Plan Commission
Meeting of March 25, 2019
Agenda item #4, Legistar #54783

This item proposes amending MGO 28.173(6)(c) to only require articulation along the lower-base facades of podium buildings.

Edgewater Hotel

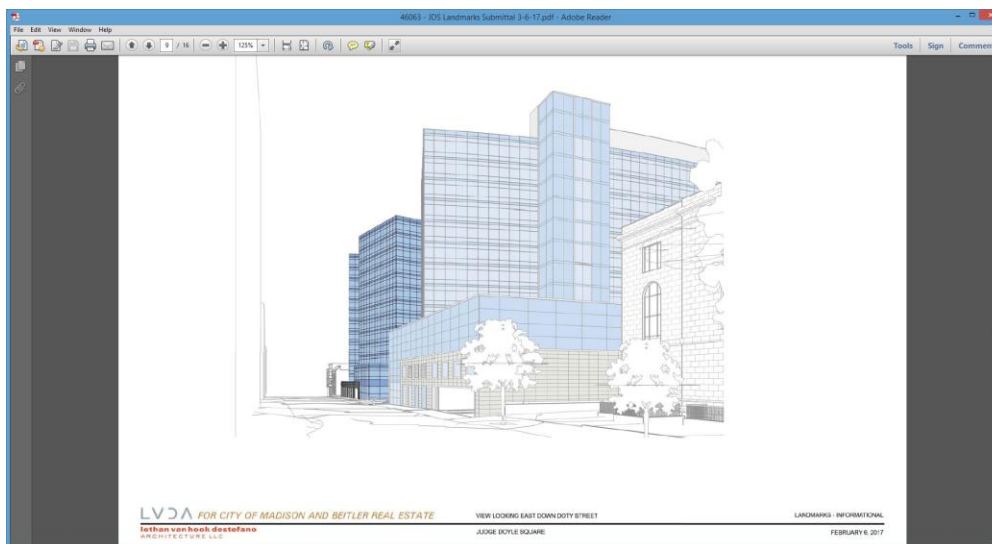
If an ordinance is being changed to allow for a specific project, the prior application of the ordinance should be considered. Although the lack of articulation might be fine for this particular project, how would other podium buildings have looked without articulation? Each of the following buildings have been described in City materials as podium buildings. I ask you to imagine how the building would look if it was an unrelenting solid mass.
